RESPONSE TO REQUEST FOR ADDITIONAL INFORMATION

US-APWR Design Certification

Mitsubishi Heavy Industries

Docket No. 52-021

Figure 5-7 Periodic Surveillance of Protection Functions Implemented via Binary Sensors Connected to PSMS (Increasing Process)

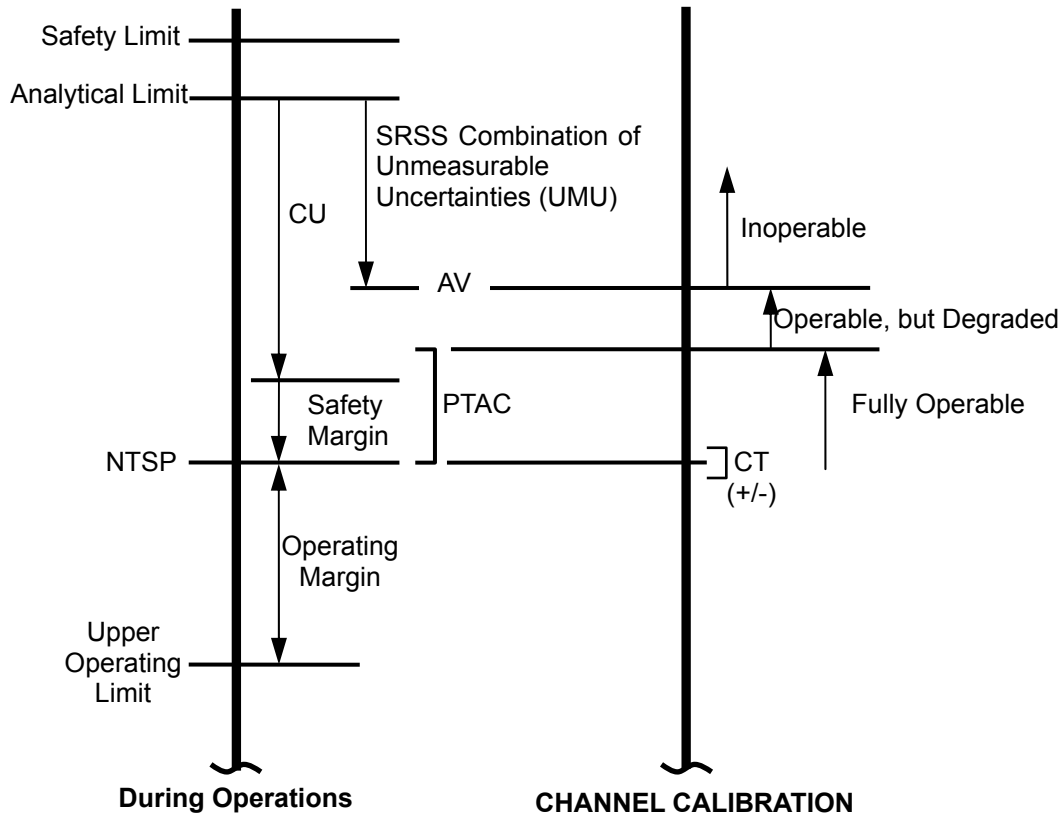
MHI had revised sections 5.3.1 and 5.3.2 of MUAP-09022 and added a new section 5.3.2.2 with a new Figure 5-7 in MUAP-09022 Rev. 2.

Figure 5-7 illustrates the relationships between the trip setpoint and other parameters for protection functions implemented via binary sensors connected to digital PSMS channels. These functions are 1) reactor trip (RT) on turbine trip (TT) via low turbine oil pressure (pressure switch) and 2) Loss of Power (LOP) signal (UV relay).

The AV is used during channel calibration to determine operability. The PTAC term is described in Section 5.4. PTAC is used (relative to NTSP) to determine degradation, thus avoiding the use of excessive tolerances as required by Reference 3.2.4 (RIS 2006-17). Plant procedures will reflect this approach (increasing process; invert for decreasing process):

- If the as-found trip value is less than $NTSP + PTAC$, then the channel is fully operable
- If the as-found trip value is greater than $NTSP + PTAC$ and less than AV, then the channel is operable but degraded, and corrective action is required to restore the channel to within specifications.
- If the as-found trip value is greater than AV, then the channel is inoperable, and corrective action is required, including those actions required by 10 CFR 50.36 when automatic protective devices do not function as required.

Figure 5-4 Channel Calibration on Analog Measurements

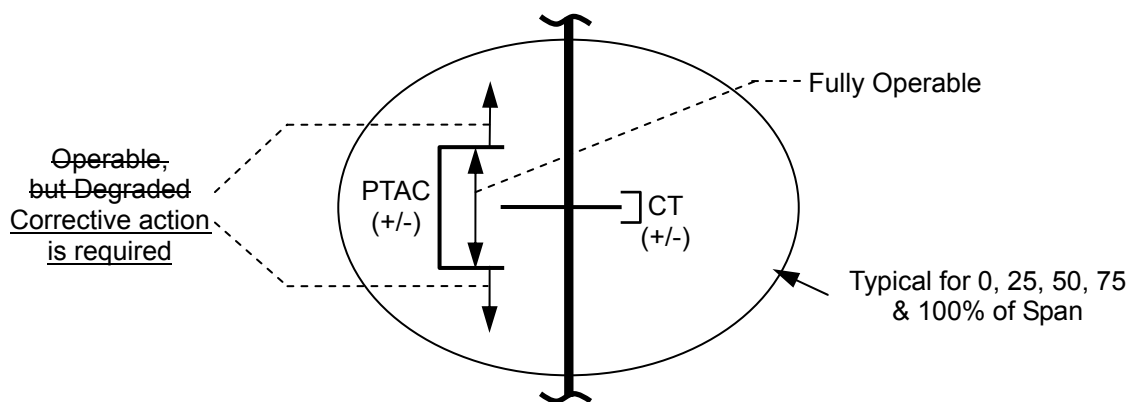
MHI will revise Section 2.0, 5.3.1, 5.3.2, 5.3.2.2 and 5.4 in MUAP-09022 Rev.3 as follows:

Surveillance testing and calibration of analog bistable channels is performed in two overlapping steps (i.e., Step 1 – Channel Calibration, Step 2 - COT ~~—Analog~~)

Figure 5-5 Periodic Surveillance of Protection Function Implemented via Analog Bistables (Increasing Process)

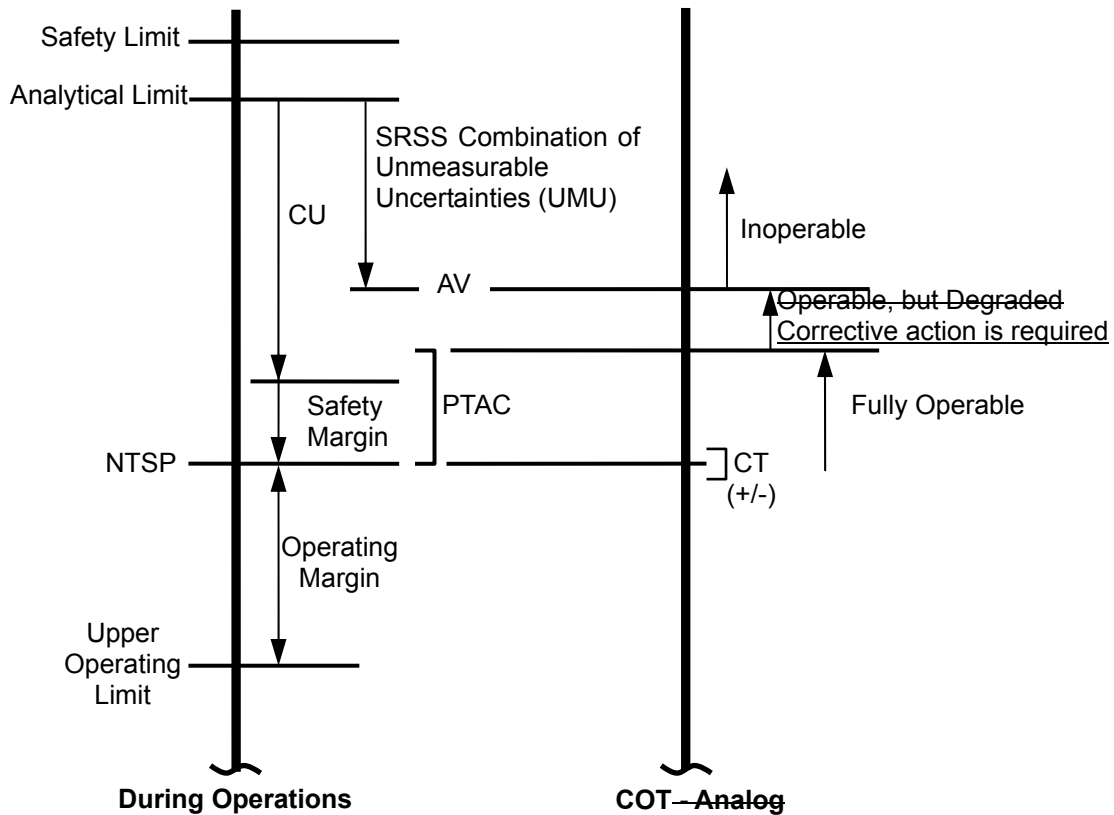
Figure 5-5 illustrates the relationships between the trip setpoints and other parameters for protection functions implemented via conventional analog bistables. This figure illustrates how NTSP is derived, and how PTAC and AV are related to the trip setpoints. The protection functions implemented via analog bistables are associated with the DAS, ~~the reactor trip on a turbine trip (TT) function and the loss of power (LOOP) signal, e.g., under voltage (UV).~~

NTSP. COT — Analog for an increasing process trip function is illustrated in Figure 5-5. The Figure 5-5 illustrates the relationships between the NTSP and other parameters for protection functions implemented via conventional analog bistables. This figure illustrates how NTSP is derived, and how PTAC and AV are related to the NTSP.

- If the as-found trip value is greater than NTSP + PTAC and less than AV, then the channel is ~~operable but degraded~~, and corrective action is required to restore the channel to within specifications.

Figure 5-6 Periodic Surveillance of Protection Functions Implemented via Digital Bistables

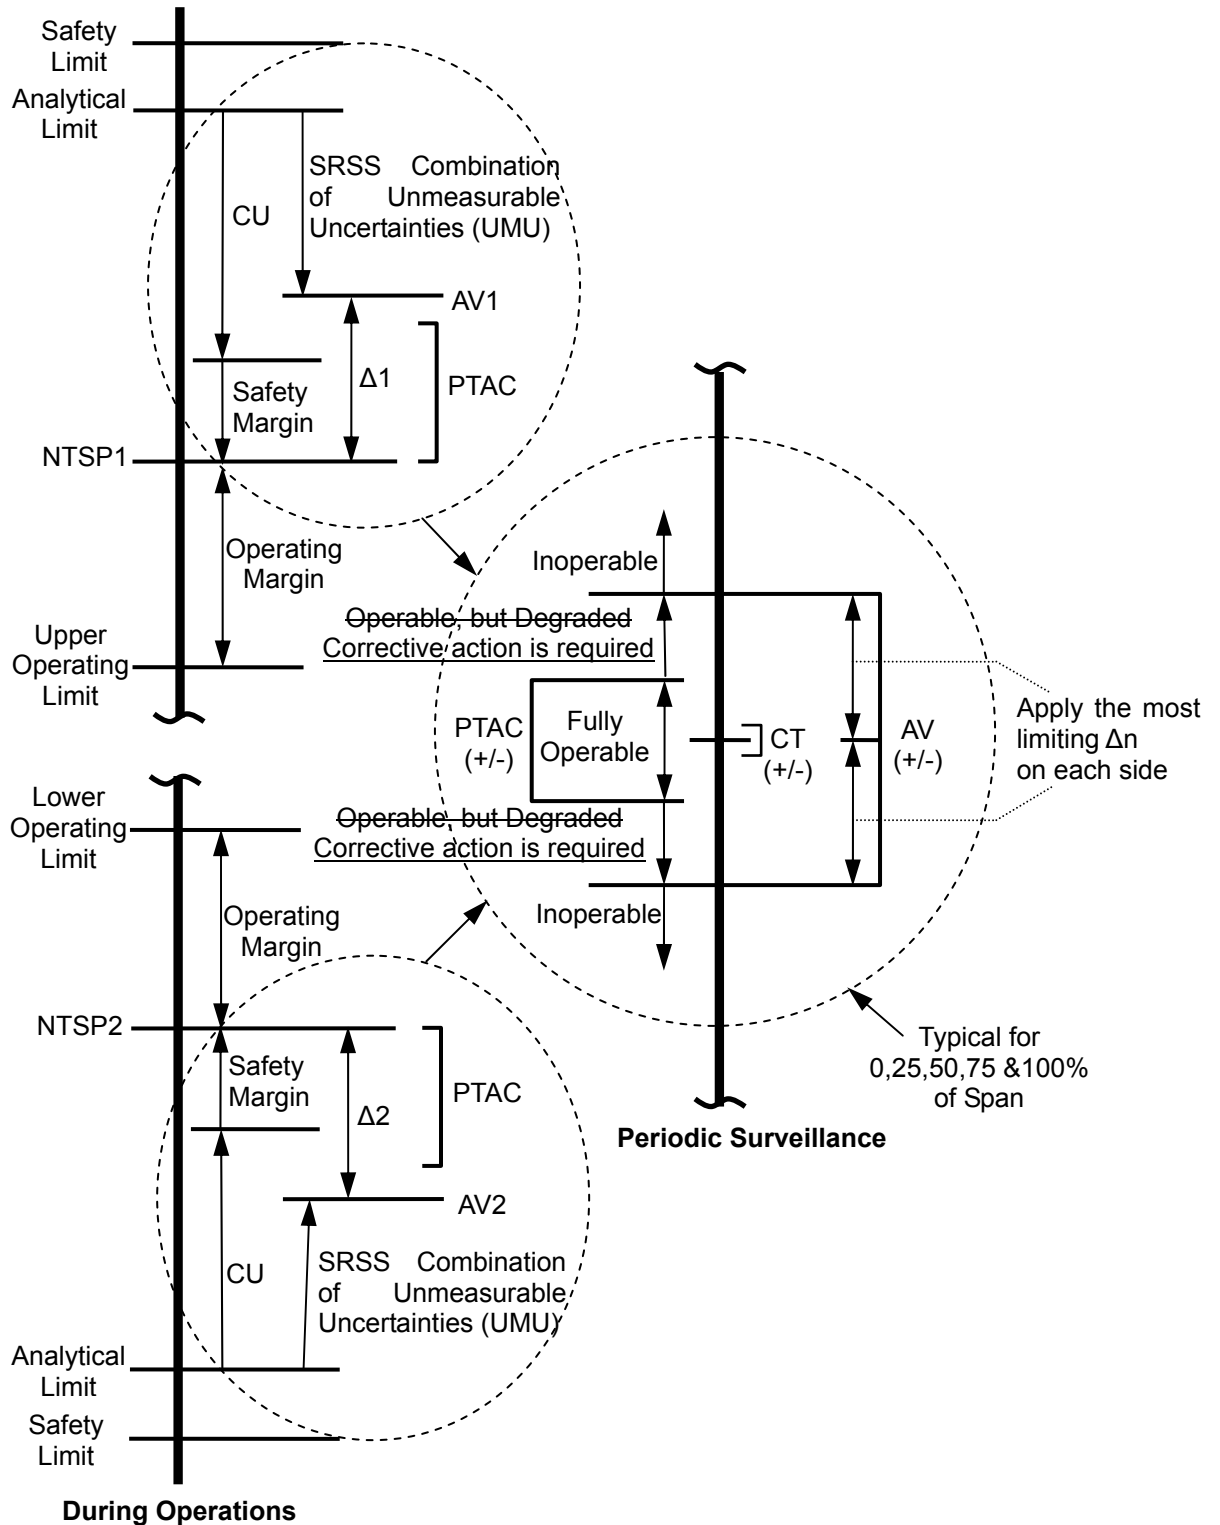
Figure 5-6 illustrates the relationships between the trip setpoint and other parameters for protection functions implemented via digital bistables. This figure illustrates how the NTSP is derived, and how PTAC and AV are related to the calibration setting. The protection functions implemented via digital bistables in the US-APWR are all those that are not implemented via analog bistables (identified above) and those not originating as binary measurements (identified below).

- If any as-found calibration setting value is outside the two-sided limits of (Calibration Setting \pm PTAC), but inside the limits of (Calibration Setting \pm AV), then the channel is ~~operable but degraded~~, and corrective action is required to restore the channel to within specifications.
